*OFFICIAL COORDINATION REQUEST FOR
NON-ROUTINE OPERATIONS AND MAINTENANCE*

COORDINATION TITLE- 13BON65 CI FG6-18 diffuser cover replacement

PROJECT- Bonneville Lock and Dam

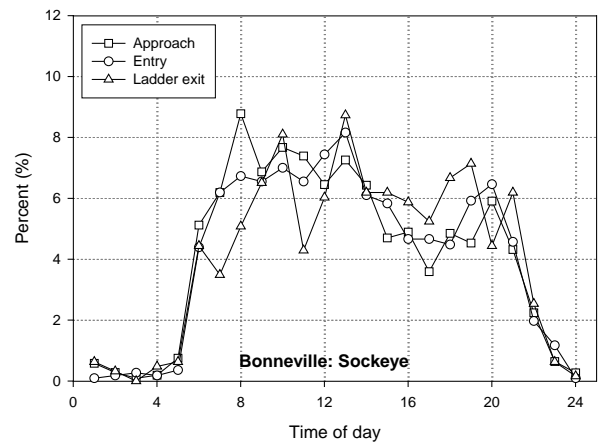
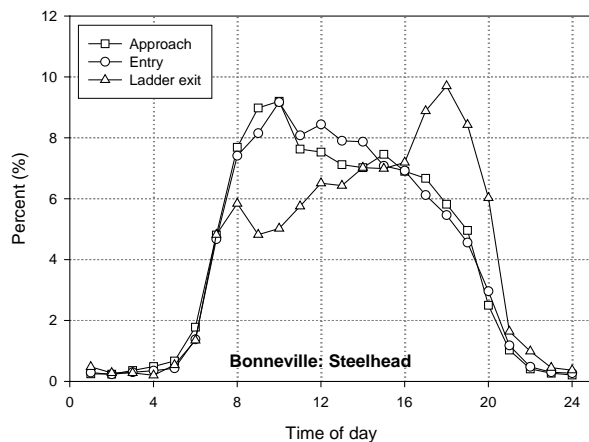
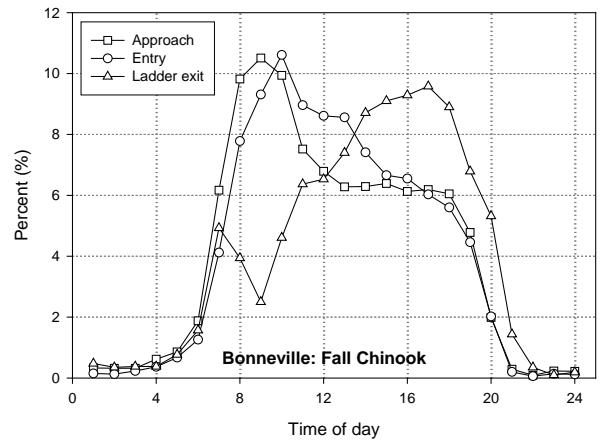
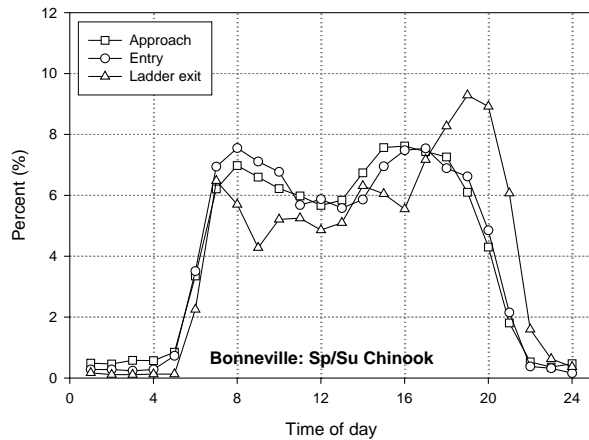
Description of the problem- As described at the 8 August FPOM, BON mid-season fishway ROV inspection. The personnel hatch in the FG6-18 diffuser pit, at Cascades Island, was blown askew. About $\frac{3}{4}$ of the hole is exposed. FPOM discussed the risks to fish. **BON will close off FG6-18 and start to schedule an emergency dive as soon as possible.**

CRITFC (via phone)- Lorz asked about the delay in getting divers (about a month after the problem was found). Aside from that, he was ok with the plan as described above.

No problem with closing but move it to 17, we have too many adults we need to insure that they keep finding the entrances and move past.

Tammy, We are ok with the general diffuser work. I would like to see the bay 1 spill moved to bay 17 to improve attraction to that side of the spillway (rather than just closing it). Also, the shift should be early in the morning to get fish keyed away from the CI entrance. It might also be a good idea to minimize the use of this diffuser to the extent the project can while maintaining good ladder conditions, at least until the project can get a permanent fix in place. Thanks, Gary

Tammy, A point of clarification. The reason we were thinking about moving bay 1 flow to the other side wasn't only for dive safety. It was also to move adult passage as much as we could to the other side of the spillway in an attempt to minimize the impact to passage. Probably too late to do this now... Gary

After discussion with the operators and Dive Safety, we feel we can do the repair with spillbay 1 open. If it affects their ability to dive/communicate, we will close it. The same goes for FV5-9--we believe the dive is possible without throttling it back but if conditions prove otherwise, we will cut back flow (NOT close). Regardless, the majority of the ladder will remain fairly normal with only lower diffusers and FV5-3 and 5-4 closed. As you know, the bulk of the ladder flow comes from the UMT and FV5-9 input so the only impact will be to entrance differential and lower weirs.

Due to the diffuser location, it looks like ladder operations will be minimally impacted (aside from closing FV5-3 and FV5-4 which may be fairly closed anyway due to tailwater). We would like to attempt to do the repairs without closing Bay 1 and with minimal throttling of FV5-9.

Final results- *The dive occurred as coordinated, with Bay 1 remaining open. The clearance was accepted at 9:18 and released at 11:51. While replacing the cover on FG6-18, divers found the cover on FG6-19 loose. Both covers were put in place and weighed down with heavy blocks (1800 lbs each). These diffusers will not be used until proper repairs can be made during the winter of 2014/15.*
